QUEENSLAND COMPETITION AUTHORITY

**RURAL IRRIGATION PRICE REVIEW
2020-24**

**ASSESSMENT OF HYDROLOGIC
FACTORS**

WS0895.1901.001
WS190040
2
3 September 2019

Figure 3-1 –Annual Diversion Exceedance Plots (SLR 2018)

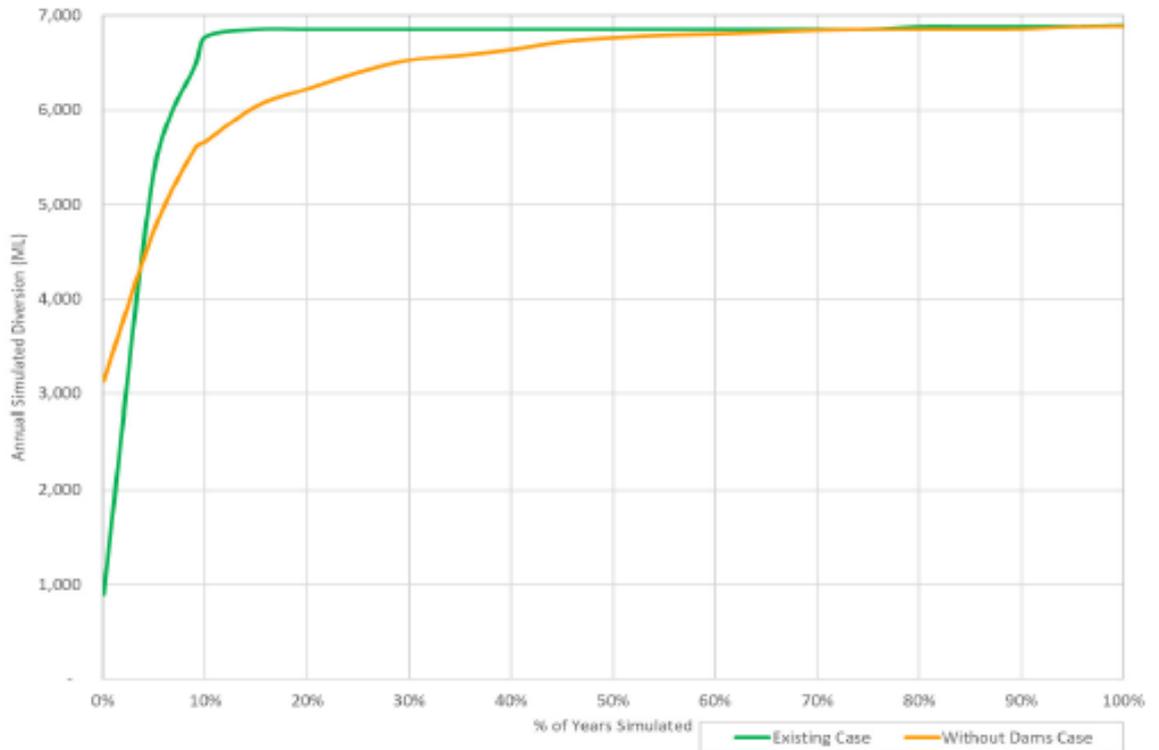
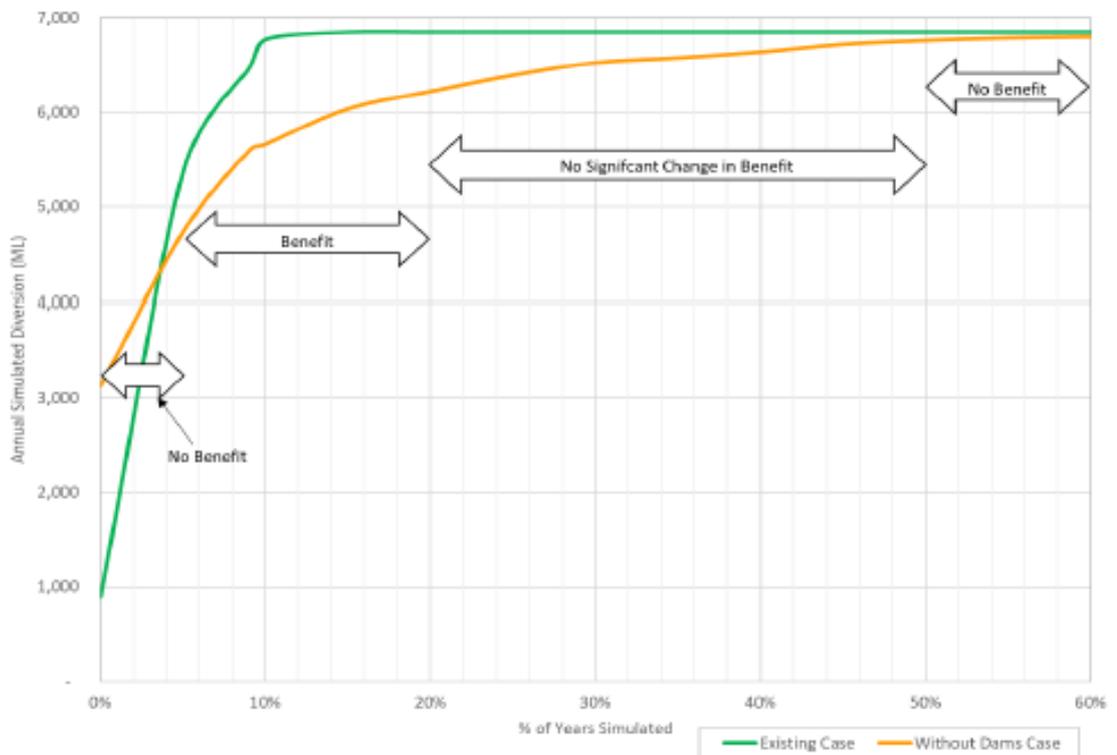
Figure 8-3 and 8-4 in the Central Brisbane Benefits Study are presented and annotated to illustrate the assessed benefit drawn from the two cases. (These figures are reproduced in Figure 3-1). The report appears to present some misunderstandings in the interpretation of this plot, which may mislead some readers. This is explained below.

The % of years in which the full allocation is available is a key measure of performance. This statistic is the point at which the plotted line drops below the maximum diversion. The green line on the plots in Figure 3-1 indicates that MP users get 100% of the nominal allocation in ~90% of years.

Performance may also be evaluated at other levels of delivery, e.g. you could compare the % of time that at least 90% of the nominal allocation (~6200 ML) fails to be delivered (~16% EC to 7% WOD, or 1 in 6 EC to 1 in 17 WOD, roughly a 3x improvement). To cut to the chase, benefit should largely be assessed by changes in the x-axis direction, rather than the y-axis direction as the labels on Figure 8-4 seem to imply.

In conclusion, it is considered that, even if the two cases were considered reasonable to indicate the relative benefits from the scheme to MP and HP WAE, that Figure 8-3 and 8-4 in SLR 2018 indicate that the MP WAE are significantly better off in the EC case compared to the WOD case.

Figure 8-3 and 8-4 in SLR 2018 are useful plots, if you ignore the somewhat misleading annotations (as discussed in Section 3.3.2). However to provide a better appreciation of the relative performance of the two cases plotting this data as a time series is illuminating. Figure 3-2 provides an example of this type of plot, which should be presented for MP WAE and for HP WAE (and for all other water user groups in the model) for both cases.

Figure 3-2 – Existing Case – Annual Diversion by MP WAE as a % of NA

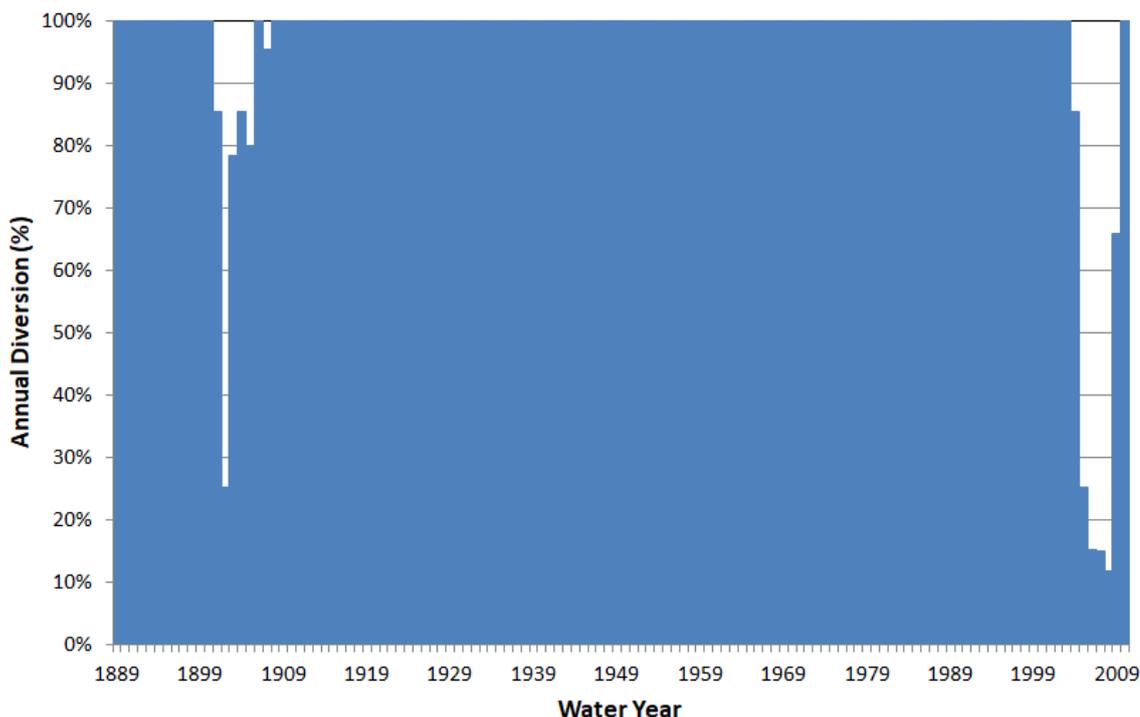
The two periods are useful, especially because they are the only two periods in which there are supply shortfalls to MP WAE users in the EC case. This is best illustrated through a time series plot of annual diversions for MP users (i.e. the same data used in the plots in Figure 3-1), see Figure 3-2. Note the annual diversion is expressed as a percentage of nominal allocation, and that the annual volumes are accumulated over the water year (July-June). The two periods of shortfall can clearly be seen, during the 1900s and 2000s droughts.

Note again the issue of the security and flexibility of the regulated supply. While the WOD case produces a larger MAD in the worst drought period (1997-2011), this diversion is at the mercy of rainfall patterns, while Figure 3-2 shows that in most years the EC case makes a substantial amount of water available to be extracted at any time of the year. This security of supply is a significant benefit, even if the average diversion is lower.

Figure 3-5 – Modified HUF Parameters for Central Brisbane

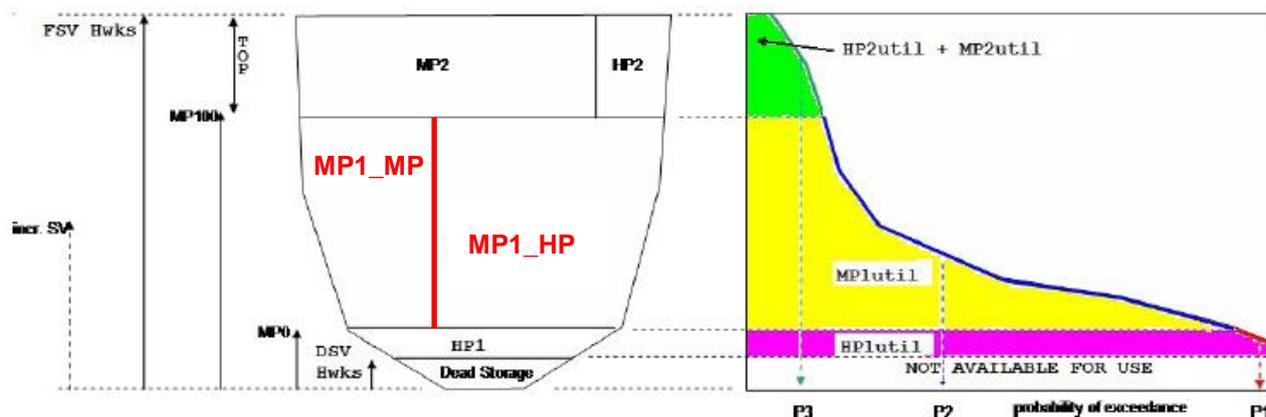
It was identified that the middle zone of storage in the Central Brisbane, between the storage volume required to supply 0 and 100% of MP AA (Zone MP1 on Figure 2-2) is clearly far in excess of the actual volume required to supply MP users this year. This occurs because the Central Brisbane AA method is simply a lookup table based on useable volume in storage, i.e. there is no attempt to work out how much can be supplied to MP users given the storage volume, estimated tributary inflows, transmission losses, etc, as done in most other schemes. In the Central Brisbane, the MP1 zone illustrated on Figure 2-2 is actually supplying water both for MP this year and security for HP allocations for the following years. The basic HUF methodology does not account for this, and thus does not work effectively for this scheme.

The modified zones for the Central Brisbane are illustrated on Figure 3-5, with the changes from the base figure (Figure 2.14 in SunWater 2018j) shown in red⁸.

Figure 4-2 – Releases to the GBA and Weir Water Levels (OD Hydrology 2018)

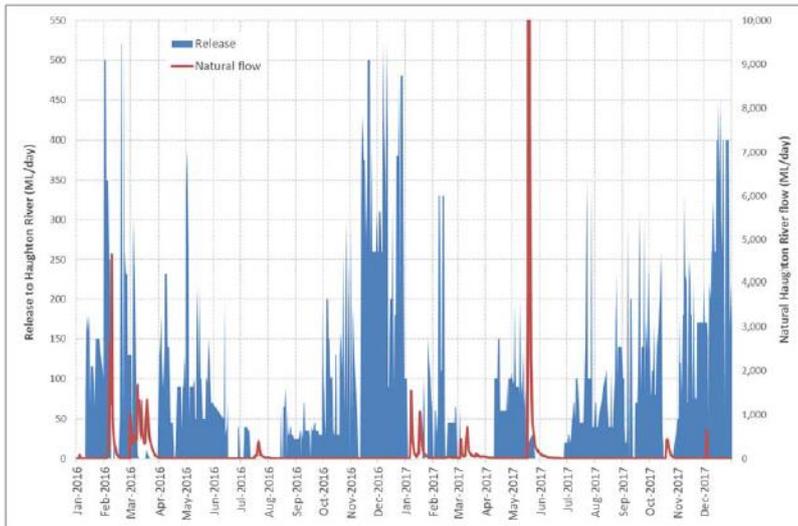
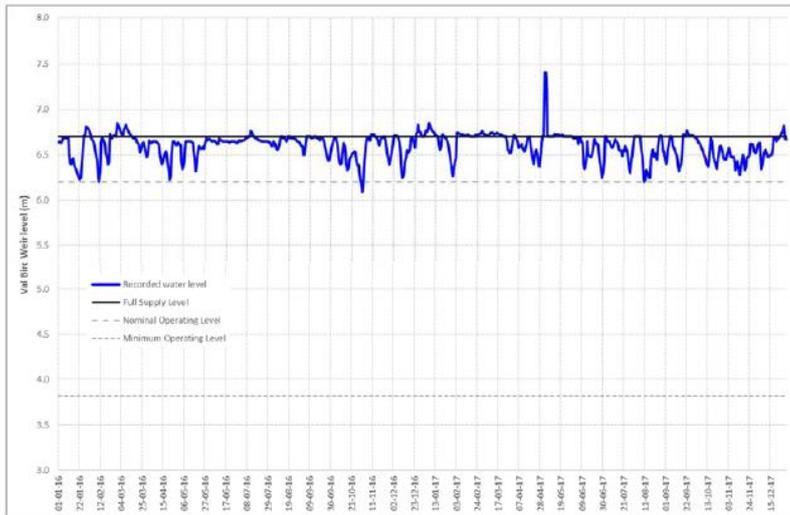
Figure 3, 4 and 5 of OD Hydrology 2018 are reproduced in Figure 4-2. The three plots are for the same time period, so the timing of the releases can be roughly lined up with the water levels they produce. It can be seen that the water level in Val Bird Weir (the middle plot) is typically close to the solid flat line that represents the full supply level, occasionally dropping down to near the large dashed line, the nominal operating level. The upper plot is showing that natural flows in the Haughton River only occur rarely – maintenance of Val Bird Weir water level near its FSL appears to be largely a consequence of the releases made by the operator.

Figure 4-2 also appears to show that Giru Weir has often been maintained at a level above its nominal operating level.

However there are operational reasons why levels in downstream weirs might not fall exactly along the nominal operating level at all times, for example, uncertainties in transmission losses, rain rejection (rain causing users to not take water they had earlier ordered), etc. However such reasons would typically only result in the occasional rise above the nominal operating level - Figure 4-2 appears to show a more systematic exceedance.

- Figure 3 in OD Hydrology (reproduced in Figure 4-2) provides a comparative plot of natural flows and supplemented releases. Based on this plot it appears that supplemented flows are made most of the time, with natural flows only occurring rarely.

Figure 4-3 – Val Bird Weir Water Levels (Kavanagh 2017)

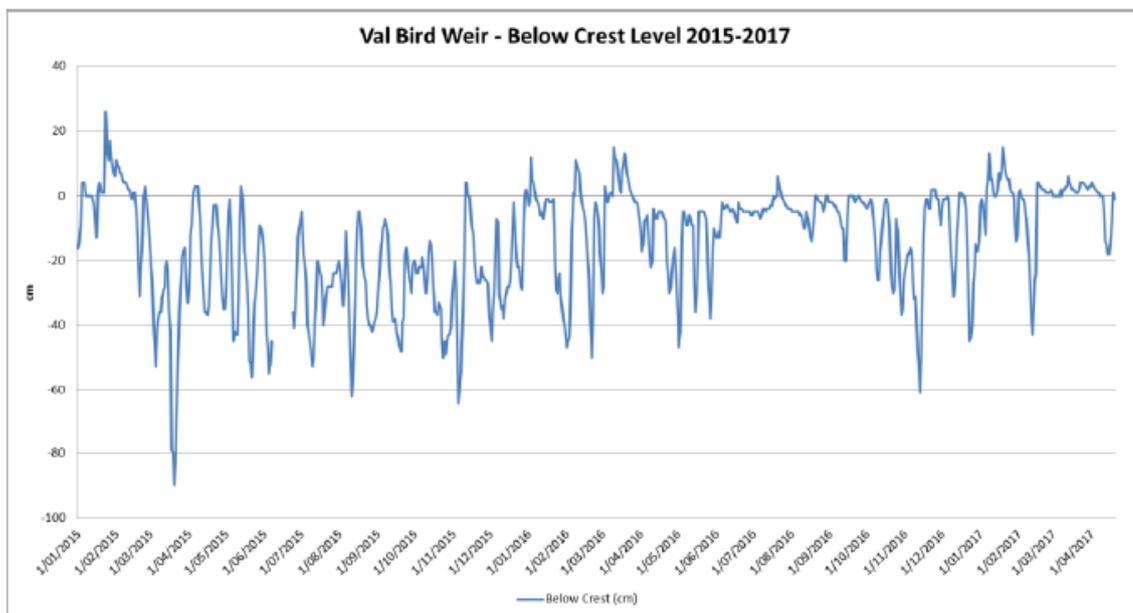
Figure 4-3 shows recorded water levels for Val Bird Weir for a longer time period, from Kavanagh 2017, and appears to show that the maintenance of levels near the FSL appears to be a more recent behaviour.

Regarding Val Bird Weir, Figure 4-3 shows that Val Bird Weir has been run near or above its FSL since around 2016. Based on the response above this may have occurred owing to large river demands occurring downstream in this period. Prior to 2016 Val Bird Weir was generally run below its FSL – it is presumed that river demand prior to 2016 was below the capacity of the outlet. Section 1 of OD Hydrology notes that there has reportedly been a transition of GBA irrigators to take water directly from surface water rather than from groundwater bores. This may be the reason for the apparent dramatic increase in demand rates direct from the river channel downstream of Val Bird Weir in recent years.

Figure 4-4 – Modelled Aquifer Levels

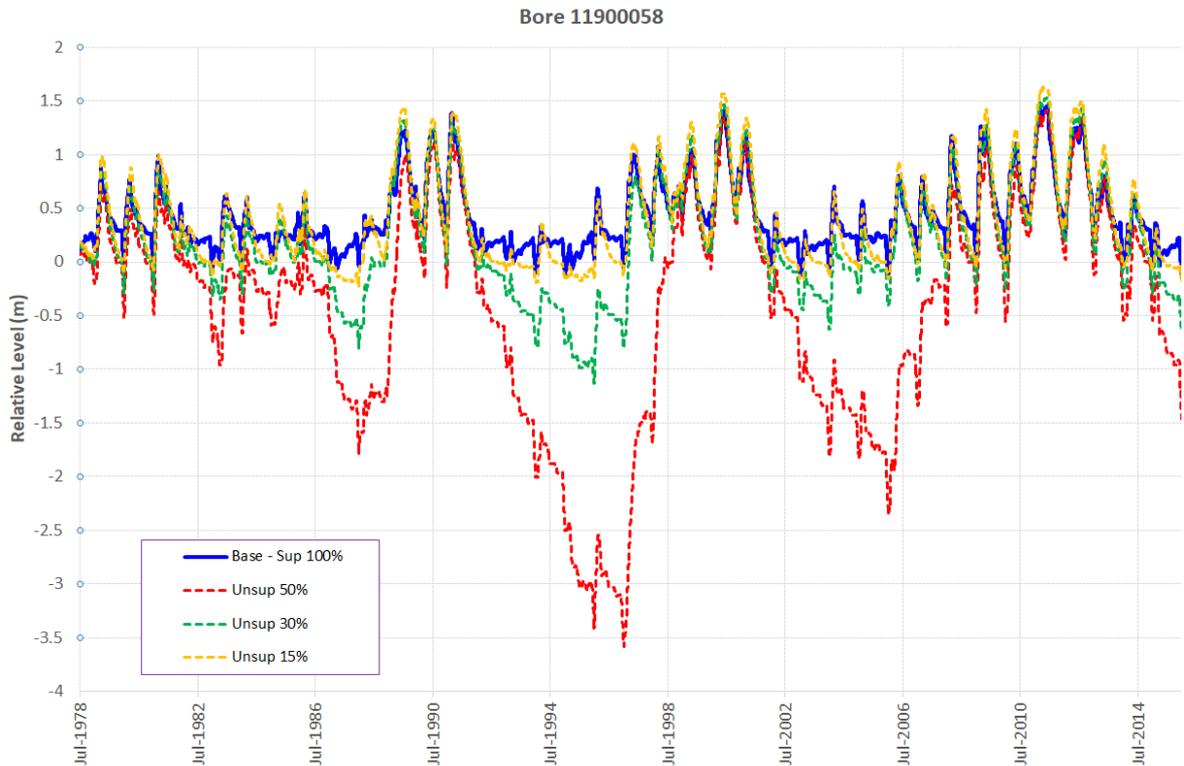
Aquifer performance may be assessed through a graph of aquifer levels for the three cases over the modelled simulation period. Figure 21 in OD Hydrology provides such a graph. From this graph it can be seen that the 30% and 50% unsupplemented cases have significantly reduced performance compared to the base case. Even in the 30% case aquifer levels are below 0m for extensive periods of time, with a minimum aquifer level of around -1m.

From the above it appears even a 15% unsupplemented demand leads to lower aquifer levels, and an increased risk of seawater intrusion, than in the base case.

Figure 4-5 – Aquifer Level Exceedance Plot

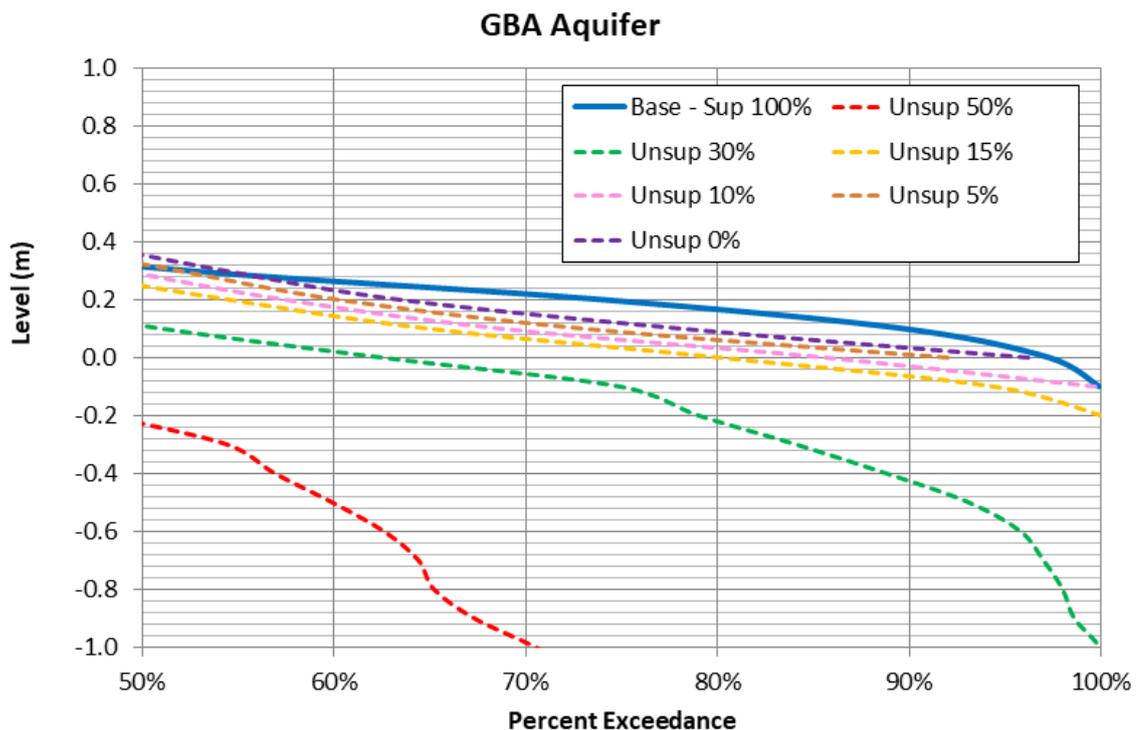
To enable a more detailed comparison of the likelihood of low aquifer levels, a level exceedance plot is provided below. This plot shows the % of time that the indicated level is equalled or exceeded in each case, with the plot focused on the lower level part of the graph. Additional cases are included on this graph, results for the unsupplemented case with demands every 5% from 0% to 15%, with the intent of enabling a close examination of the case that provides similar performance to the base case.

The different nature of the curves on this plot does not make it simple to assess which unsupplemented case provides the same aquifer level performance as the base case. If the lowest modelled level is used as a benchmark, the 10% unsupplemented case would be chosen as being compatible, but it can be seen that this case gives aquifer levels ~0.12m lower than the base case on about 40% of the days in the simulation period. If the performance at the, say, 90% exceedance percentage was chosen, not even the 0% demand case provides the same level of performance as the base case.
